Safety Recall: 26V337
May 2026

IMPORTANT SAFETY RECALL

Product Safety Notice

Models Included 2025 - 2026 Paradigm 5th Wheels.

Fig. 1

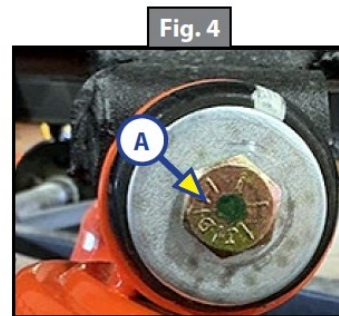
Alliance RV has determined that certain 2025 – 2026 Paradigm units equipped with CURT Touring Coil Suspension systems may contain shock retaining bolts that were improperly tightened during production of the suspension assembly. Under certain operating conditions, the retaining bolt head may fracture which could allow the retaining washer and/or bolt head to detach from the vehicle and become road debris, increasing the risk of a crash.

1. Starting with the inside shocks, loosen and remove the two existing 3/8"-16 x 3/4" thread forming screws (Fig. 1A) and washers (Fig. 1B) securing each shock absorber onto its posts (Fig. 1C). Retain washers (PN 249853) for reinstallation in Step 2.

Alliance RV will reimburse authorized service providers to inspect and replace the affected shock retaining bolts with updated hardware. The repair involves removing the existing shock retaining bolts and replacing them with updated grade 8 fasteners utilizing thread locker and revised torque specifications.

2. Reinstall previously-removed washers onto two new 3/8" - 16 x 3/4" Grade 8 hex head bolts.

Fig. 2

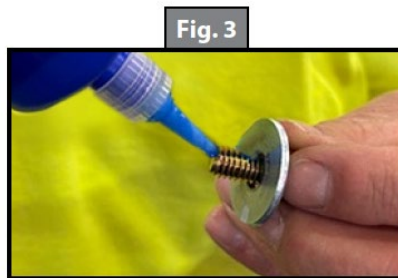
NOTE: Some kits will come with bolts pre-coated with thread locker instead of 0.02oz capsules of Loctite. If the bolts are pre-coated (Fig.2), skip step 3.

3. Apply two threads of thread locker to the Grade 8 bolt threads (Fig 2).
4. Install new bolt assemblies by hand for a minimum of three full threads (or three turns) before proceeding to step 5.
5. Torque new Grade 8 bolts to 20-30 ft-lbs. Do not over torque bolts.
6. Repeat procedure on all other inside and outside shock absorber bolts.
